CITY OF PORTLAND, MAINE

PLANNING BOARD

Project Name:	Baxter Academy of Science and Technology	Project ID:	2017-022
Address:	185 Lancaster Street	CBL:	025 F001001
Applicant:	Baxter Academies of Maine		
Planner:	Shukria Wiar

PLANNING BOARD REPORT PORTLAND, MAINE

Figure 3: Layout of the new sidewalk and bicycle parking across Lancaster Street.

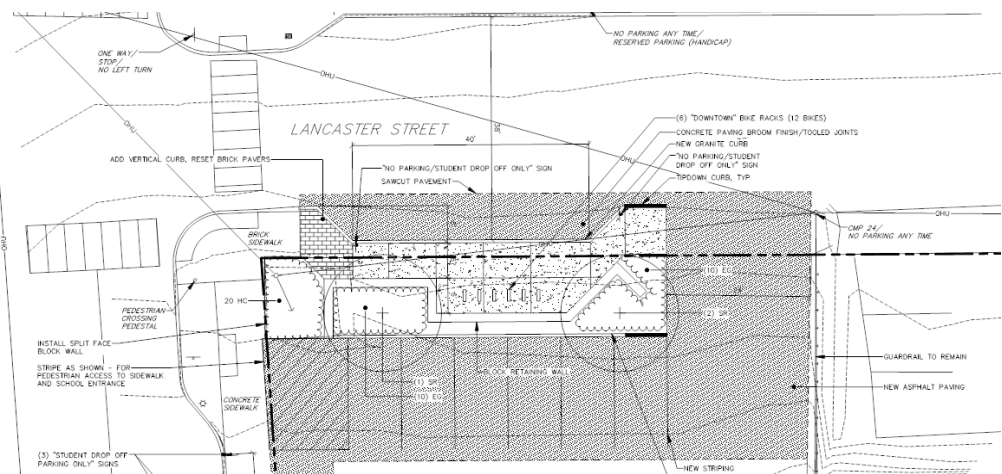
Across Lancaster Street, there is a surface parking lot that is associated with the existing uses in the surrounding buildings. Currently there are seven parking spaces that back onto Lancaster Street. Those spaces will be eliminated as part of this project and replaced with a sidewalk and bicycle spaces.

Staff Comments: The surface parking area is an existing lot. The seven parking spaces that back out on Lancaster Street will be eliminated as part of this project and replaced with a sidewalk, bicycle spaces, and some landscaping. The rest of the surface parking lot will not be improved. The improvements meet city standards.

The seven spaces that back out on Lancaster Street will be eliminated as part of this project and replaced with a sidewalk, bicycle spaces, and landscaping. This area may be the only opportunity for landscaping on the proposed site; the rest of the surface parking lot will not be improved. Jeff Tarling has reviewed the proposed landscaping and finds it acceptable.
